REMARKS

The claims presently outstanding are Claims 1-18. By the foregoing amendments, various Claims are sought to be amended. These changes are believed not to introduce new matter, and their entry is respectfully requested.

Fig. 47

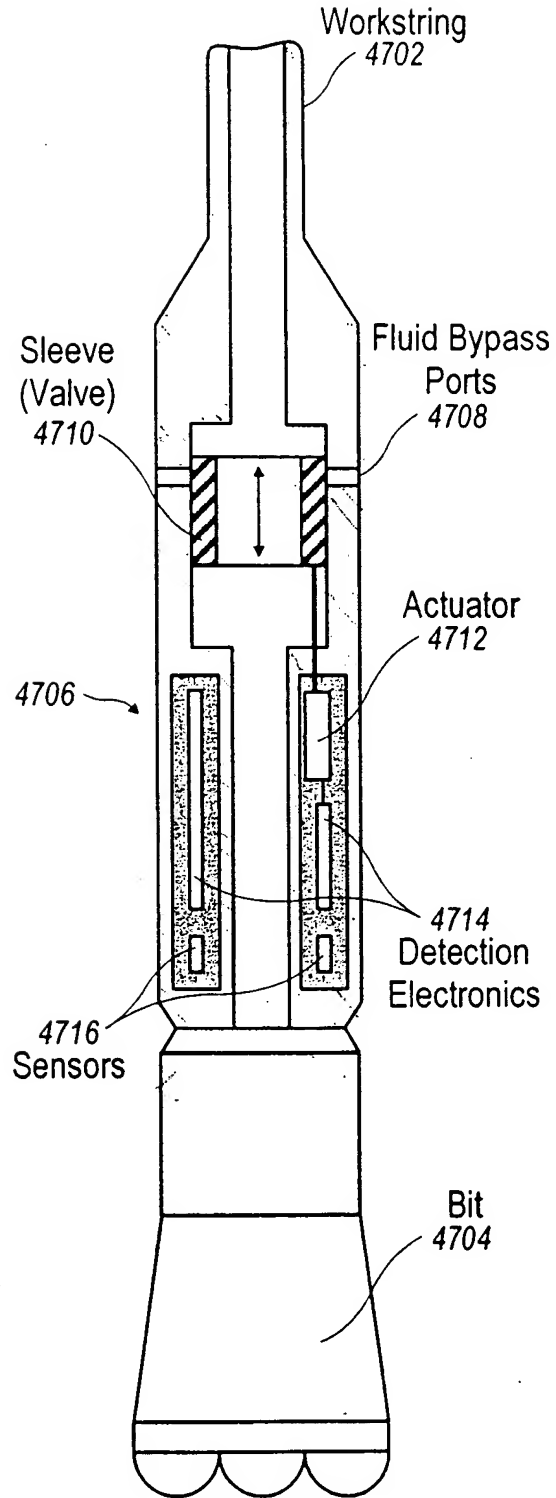
The Examiner is thanked for noting the informalities in the specification and drawings, which have now all been corrected. However, the Rule 83 objection stated in paragraph 9 is respectfully traversed: note that the Rule does not specify what level of detail is required. Figure 47 shows a general view of a sleeve valve mechanism which can be used to satisfy the claimed relationship, but numerous mechanical implementations are possible. This particular point of invention does not relate to a particular mechanism, but rather to a new functional relationship. This relationship is shown very clearly in Figure 48: in this embodiment the pressure drops when the port opens (indicating failure) and then goes back up to the "Closed Port" level so that the bit can be run to failure if desired. This functional relationship is described, for example, on page 41 as follows:

A microprocessor or digital signal processor is used to implement the detection algorithm and monitor the sensors. Additionally the processor will control the actuator, which opens and closes the sleeve valve. Of course any valve type could be used. It may be desirable in some cases to close the bypass valve after a certain delay, so normal drilling can proceed if desired. **Figure 48** shows the surface pressure sequence associated with this type of operation.

That is, the application does not purport to require a mechanism for

irreversible movement: what is being described is a control relationship.¹
